**MODIFICATION REQUEST:
61 Mobbs Lane, Epping (Former Channel 7
Site)
(MP 10_0107 MOD 1)**

Director-General's
Environmental Assessment Report
Section 75W of the
Environmental Planning and Assessment Act 1979

October 2011

Figure 3: Building 2 Lower Parking Level Section

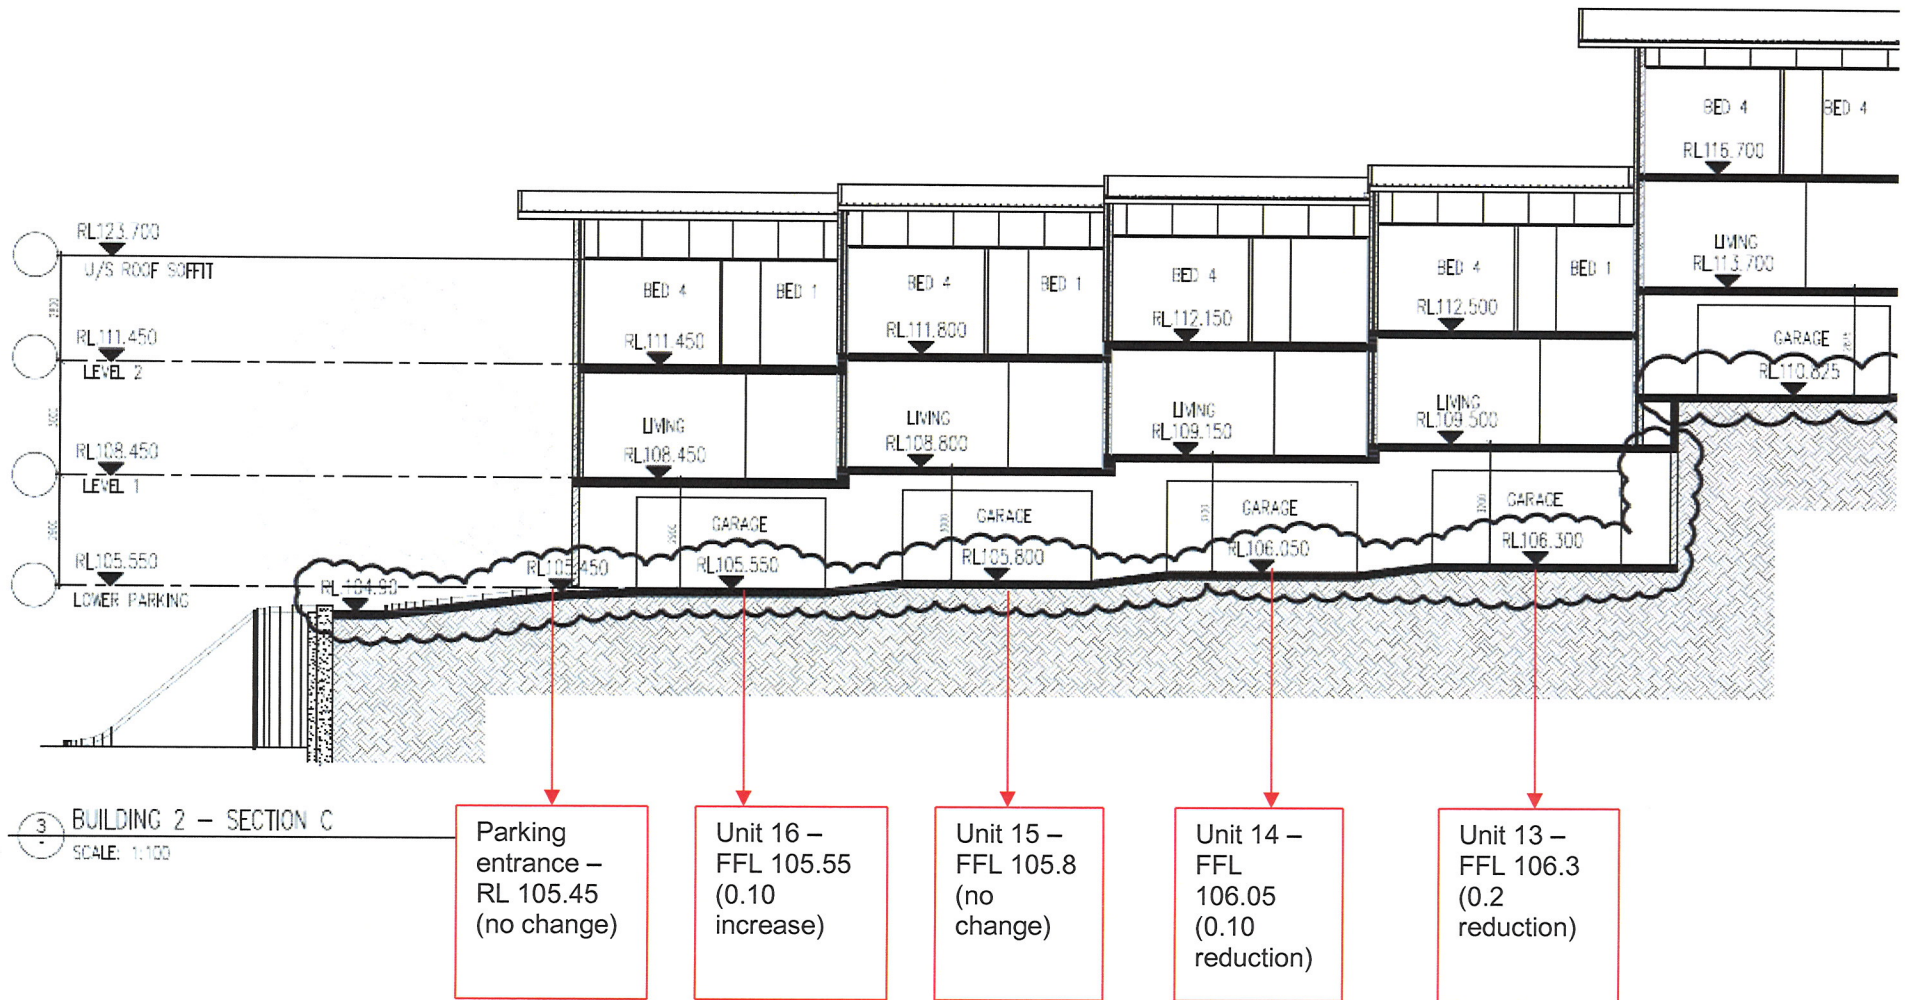
Changes to the finished floor levels (FFL) of the garages for the lower parking level of Building 2 are shown in **Figure 3** overleaf. The garages for units 13 and 14 are slightly lowered (10-20 cm) and for unit 16 it is raised (10 cm). The FFL changes to the garages at the parking level of Building 2 are shown in **Figure 4**. The FFLs for units 6-9 are slightly decreased (2-17cm), and the FFLs for units 10-12 are raised (2-75cm). The RLs for the parking level driveway and ramp have a minor decrease (17cm).

The changes to the FFLs and RLs of Building 2 at the lower parking and parking levels will result in a gentler slope into and within the parking garages. These amendments are minor and will not increase the height of the basement above ground level or the overall height of the buildings. Also, they are required in order to comply with Condition B1 of the original approval. Therefore, the department considers these amendments are acceptable.
